# Product Safety Recall

**Gorilla Extension Ladder 150kg Industrial - EL12/21-I.** Manufactured between December 2006 and October 2014. Available for sale from January 2007 to November 2014.

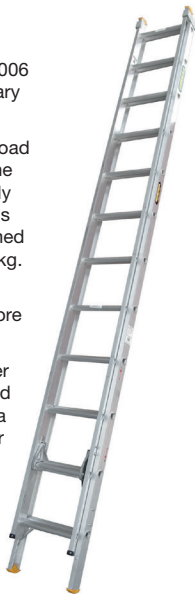
**Defect:** The ladder does not perform to 150kg load capacity as claimed on the packaging and on the load rating label. Consumers may mistakenly rely on the claimed load rating to assess whether it is safe for them to use. Recent testing has confirmed that the ladder should have a load rating of 120kg.

**Hazard:** There is a possibility of a fall injury occurring if the ladders fail while loaded with more than 120kg.

**What to do:** Consumers must not use the ladder for loads of more than 120kg. Consumers should contact Hartman Pacific in order to arrange for a new rating label and load rating stickers for their existing ladder, or call Customer Service if you believe that you will use the ladder with loads greater than 120kg.
